City of Gainesville
Department of Community Development
Current Planning Division
Summary of Technical Review Committee Comments

Petition: 48SUB-01DB

Project Name/Description: Design plat review for 64 lots on 13.56 acres MOL. Located in the 5000 block of Northwest 8th Avenue, north side. Eng, Denman & Associates, Inc., agent for Hillcrest Development Co. of Gainesville.

Design Plat of:
HILLCREST
Single Family Residential
Planned Development

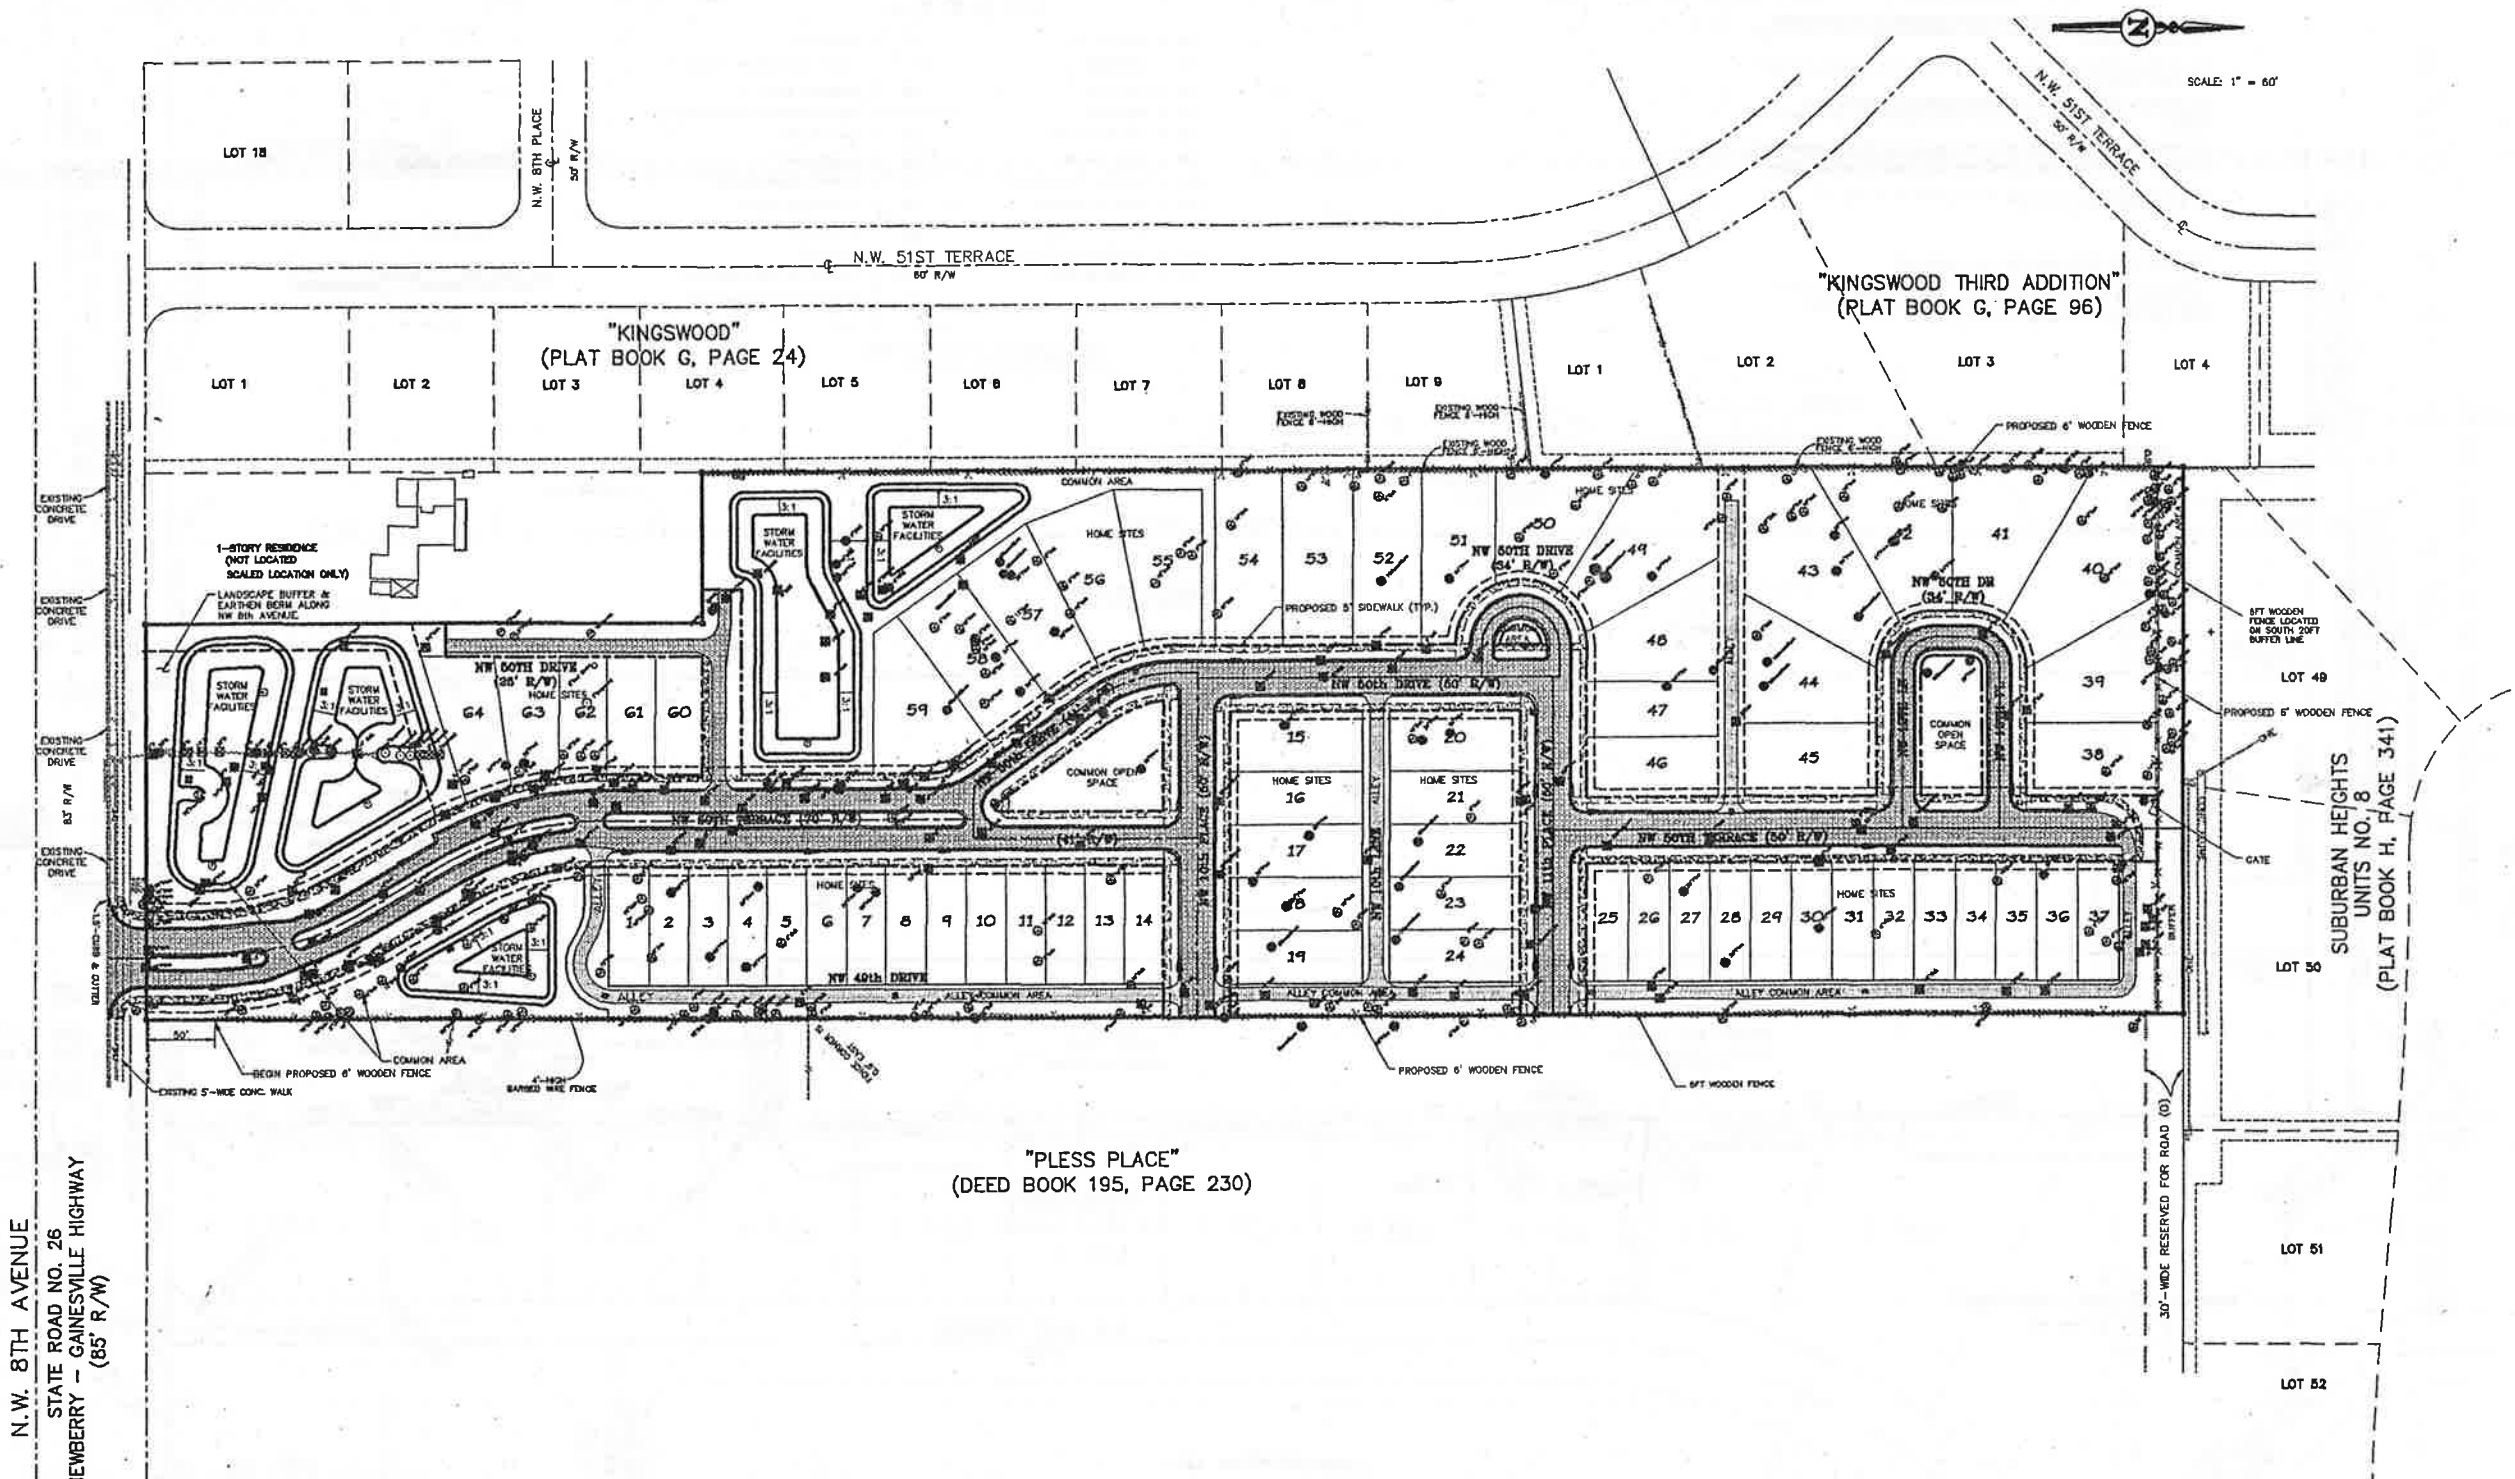
2. The design plat shall be adjusted to show the trees that must be removed due to Southern Pine Beetle infestation, as determined by the Division of Forestry and the Parks and Recreation Department. Please modify notes on the design plat to address the infestation.

1. Please revise note #10 on the design plat to state that the limits of the stormwater basins will be maintained by the City of Gainesville for function only.

UTILITY ALLOCATIONS

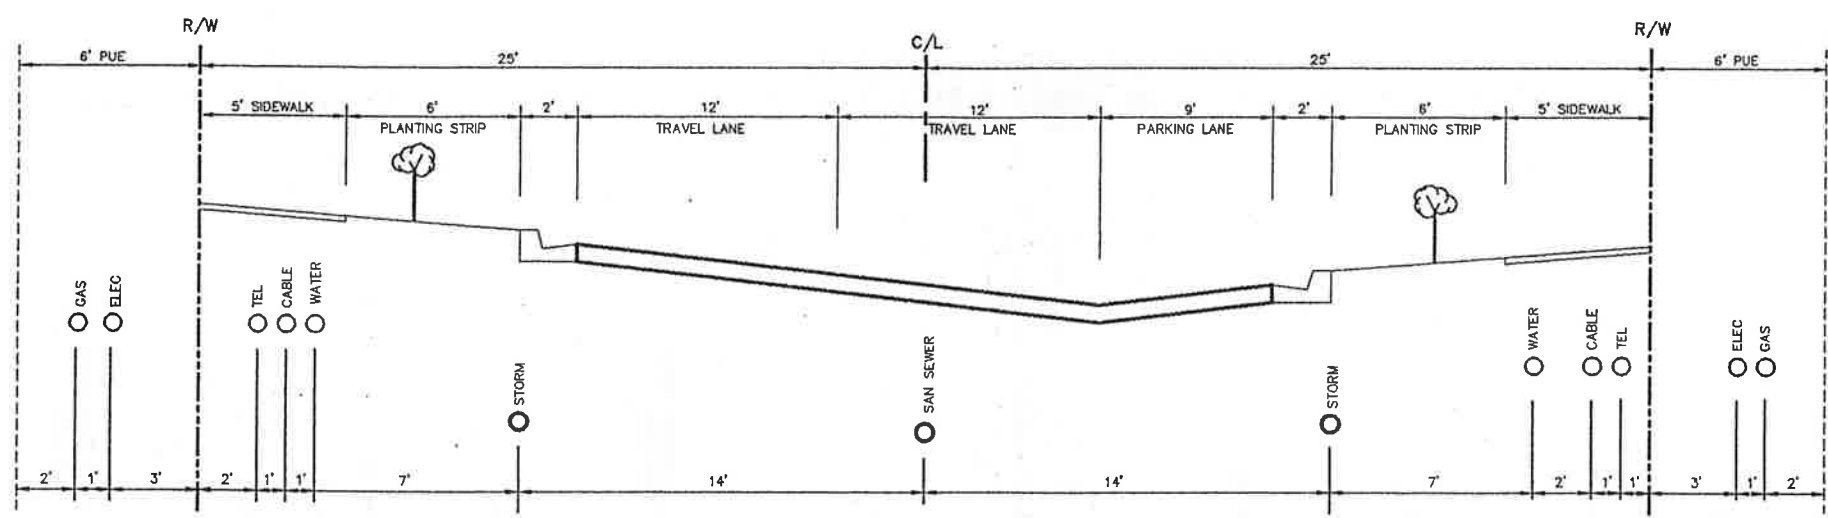
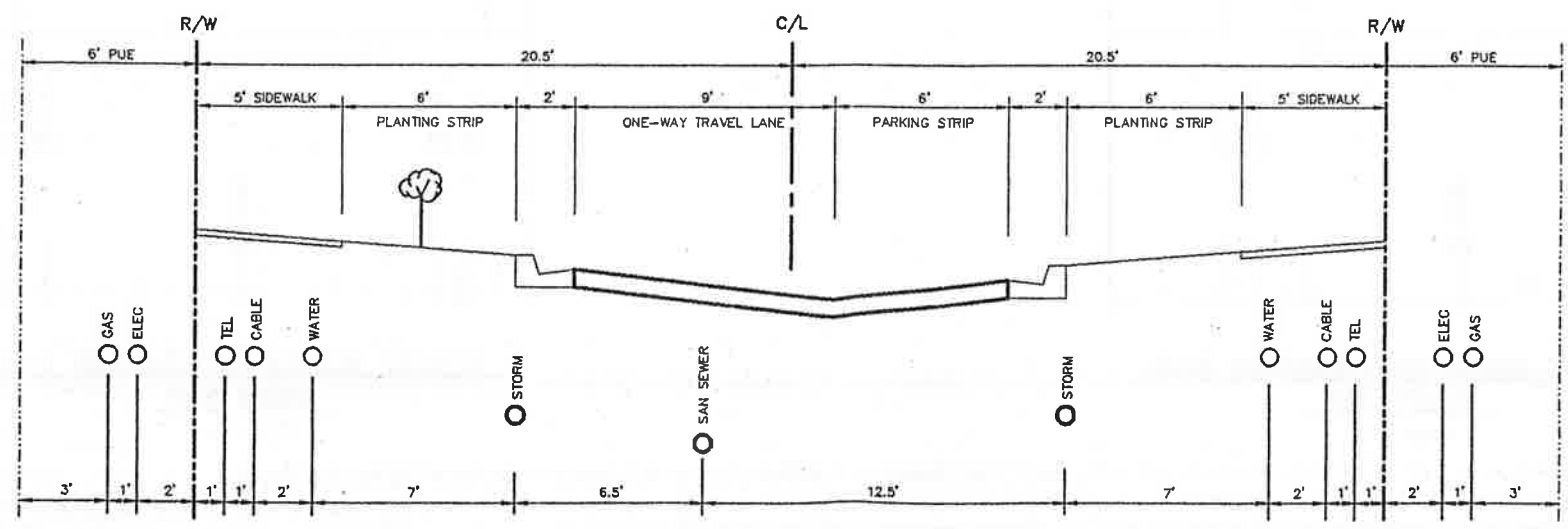
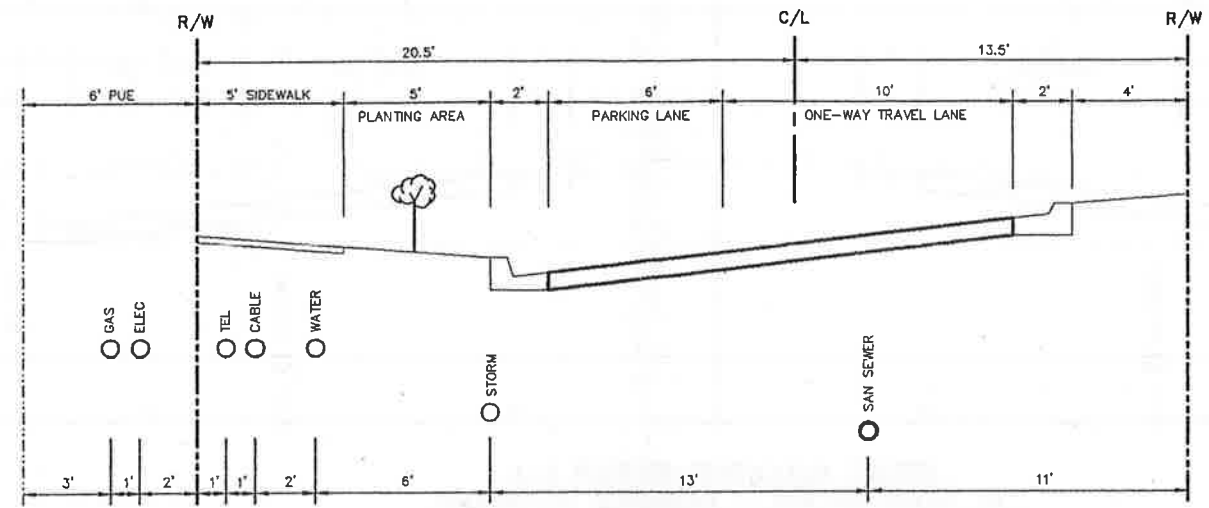
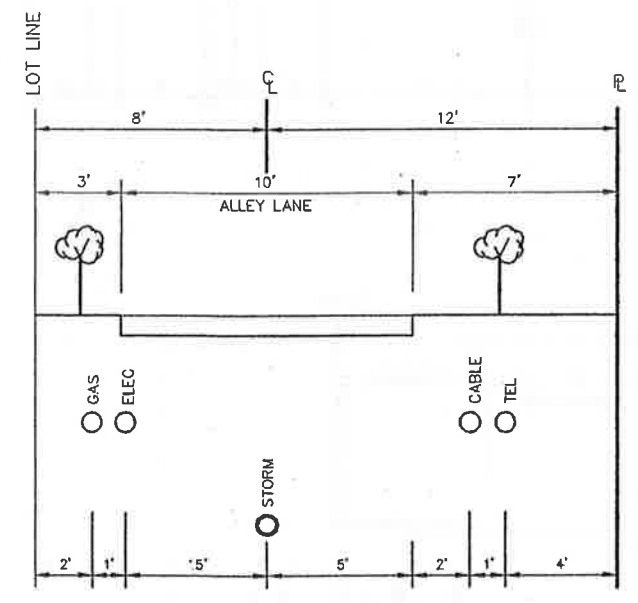
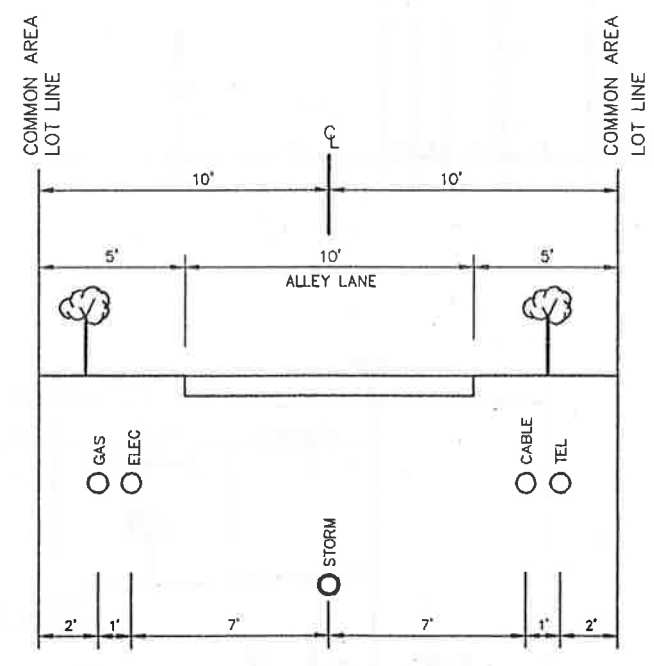
5. The cover sheet shall list the adopted design standards of the PD.
6. The width of the proposed alleys and rights-of-way on the utility allocation sections must be consistent with the design plat. For example, the width of the alley common area is shown to be 25 feet on the design plat. However, the utility allocation Section E-E shows only 20 feet. Please correct and reference Sheet 7 of the Approved PD Layout Plan Map.
7. The dimensions shown in Section B-B on the Utility Allocations Sheet exceed 50 feet. Please correct and reference Sheet 7 of the approved PD Layout Plan Map.
8. Section C-C on the Utility Allocations Sheet must be corrected to show that a 6-foot wide "Parking Lane" is proposed between the curb and one-way travel lane.
9. Please label the 4-foot area shown between the back of curb and right-of-way line shown in Section D-D on the Utility Allocations Sheet.
